MEMORANDUM FOR THE RECORD

Subject: Final minutes for the 09 May 2013 FPOM meeting.

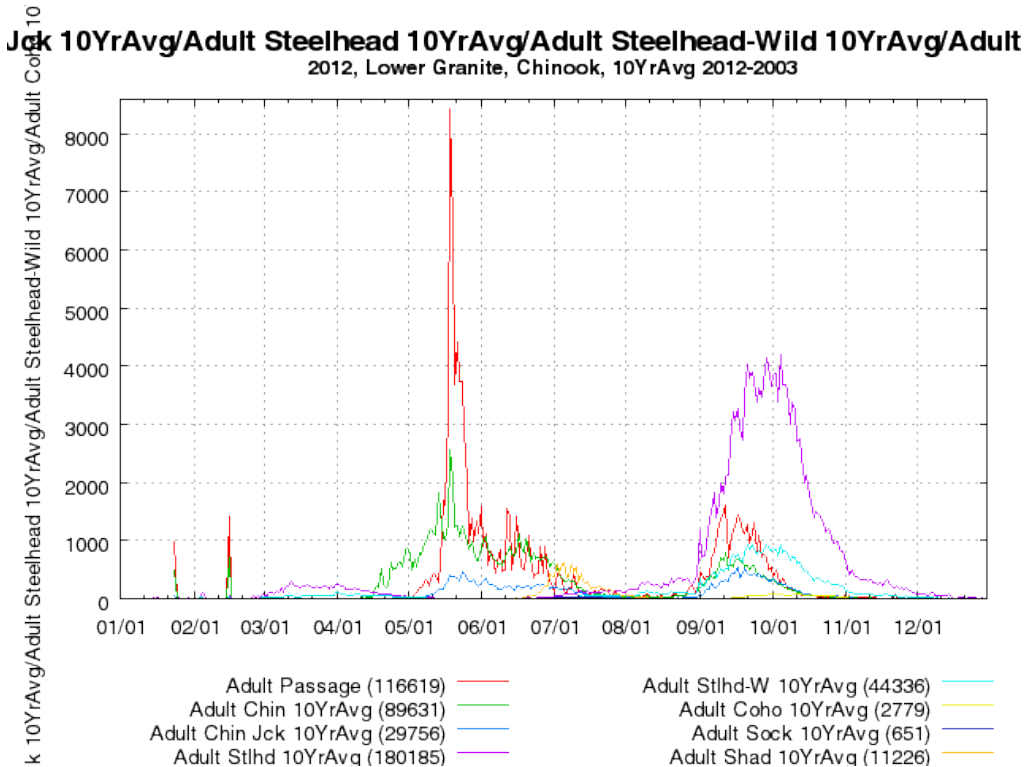
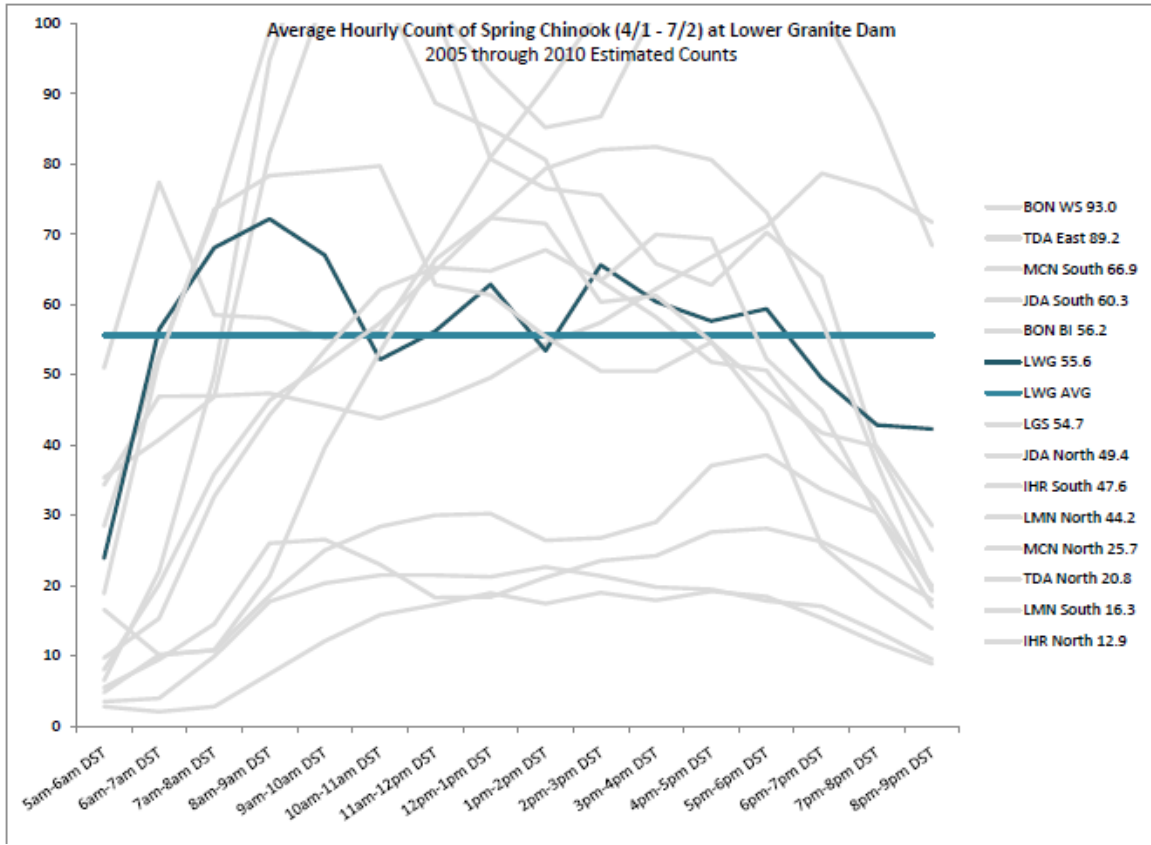
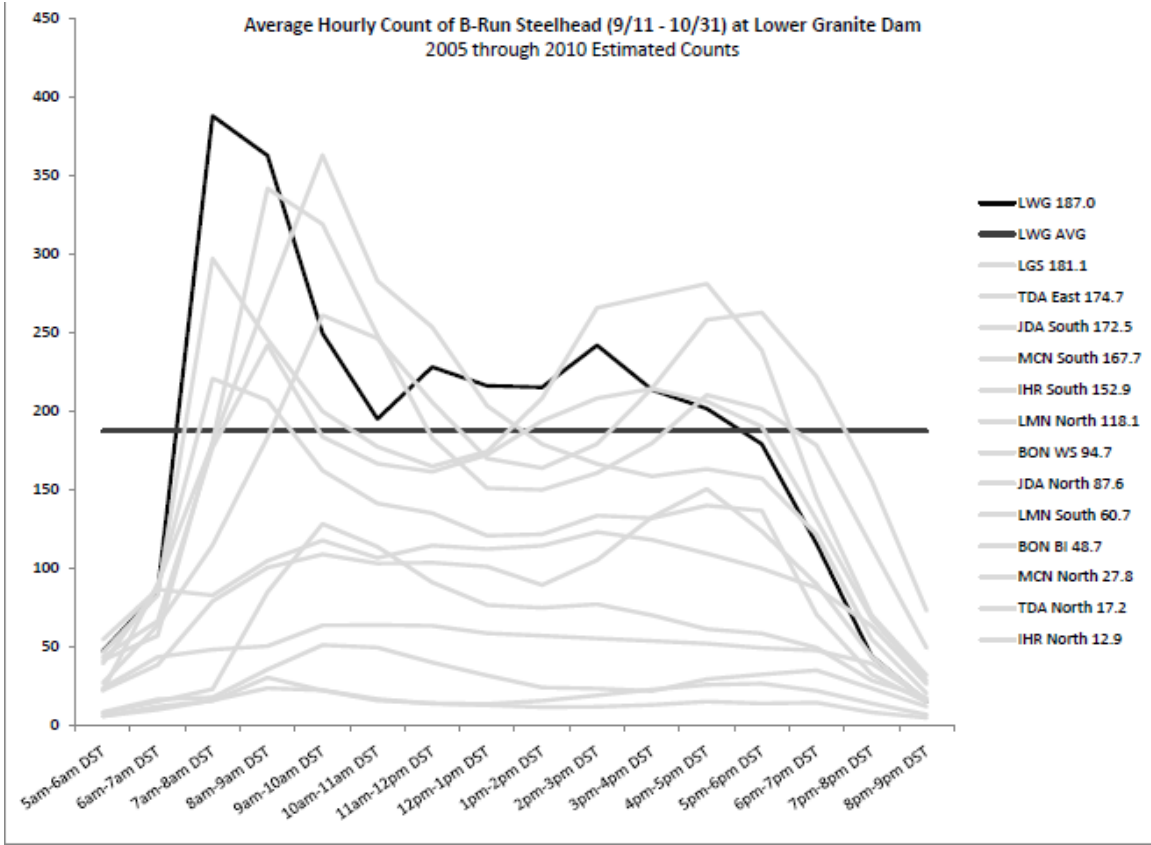
1. The only survey so far has been conducted at the Erection Bay where the worst blistering has occurred. Depending on what is discovered during the inspection on July 15-16, would it be possible to conduct 1/2 the work this year and 1/2 next year, starting in the most problematic areas. The coordination form states work should be accomplished in 1-2 years. If work only extended through August, looking at adult steelhead and Chinook passage, it would avoid the September period when this outage would potentially have the largest impact on adult passage.

2. If work in September cannot be avoided, can work be accomplished at night- at least during the high adult passage periods. The coordination form does discuss the temperature requirements between 50-100 deg F. I know during Sept nighttime lows do begin to drop off pretty quickly, just wondering if the nighttime option had been fully explored.

3. If all work must be completed this year, extending into Sept and not at night: can the outage be delayed daily from 830-2130 to maybe 1000-2300, especially during period when adult numbers increase or have this happen if we begin to see an impact on daily passage. Looking at your daily passage plots for LGR, having PH attraction for an extra 1.5 hrs in the morning would help.

Tom Lorz (CRITFC) asked if the turbine units can be kept running until at least 0900 hours in the morning each day to provide attraction for adult salmonids to the fish ladder entrances.

Gary Fredricks (NOAA Fisheries) recommended that the spill pattern at Lower Granite be re-examined to ensure that there is flow loaded on the side bays for optimal attraction of adult salmonids to the fish ladders. He asked if the turbine units can be kept running until 0900 or 1000 hours each day to provide attraction for adults to the ladder entrances.

Bill Hevlin (NOAA Fisheries) said that the current Lower Granite spill pattern in the Fish Passage Plan is a "crown" pattern to guide adults along the sides of the spill to the ladder entrances. The adult fish daytime counts need to be monitored for the duration of the roof repair job. If we find that adults are being delayed, perhaps one or two stops can be taken from the middle spill bays and added to the north bays. He recommended that the turbine unit outage be delayed till 0900 or 1000 hours each day if possible.

Comments received were discussed with the Lower Granite roof repair PDT and taken into consideration to finalize the turbine unit outage schedule and daily work window for the contractor. The unit outage schedule will be as follows:

OUTAGE 1: Moisture survey, 15 July 2013 and 16 July 2013 (2 days), 0930 - 2300 hours

OUTAGE 2: Roof repair work:

~~0510~~ August 2013 - 11 August 2013, 0930 to 2300 hours

12 August 2013 at 0600 hours to 16 August 2013 at 2300 hours, ~~0600 to 2300~~ 24 hours per day between those dates (0600 to 1800 hours already approved for dole testing)

17 August 2013 - ~~1922~~ September 2013, 0930 to 2300 hours

The work shift available to the contractor will be 10.5 hours long (includes 0.5 hour lunch break) during the 1100 to 2130 hours time frame, with the remainder of the time needed to prepare and place the safe clearance tags and remove the tags each day. Project personnel have determined that the line feed for station service will need to be switched twice each day, at the start and end of the daily powerhouse unit outage. This will result in the AWS pumps being out of service for approximately 5 minutes at 0930 hours and again at 2300 hours.

For the duration of the roof repair dates, adult salmonid numbers passing the count window will be monitored. If the data indicates that adult fish passage is being delayed, in-season coordination will occur with the regional agencies to change the spill pattern to help with adult fish attraction to the ladder entrances.
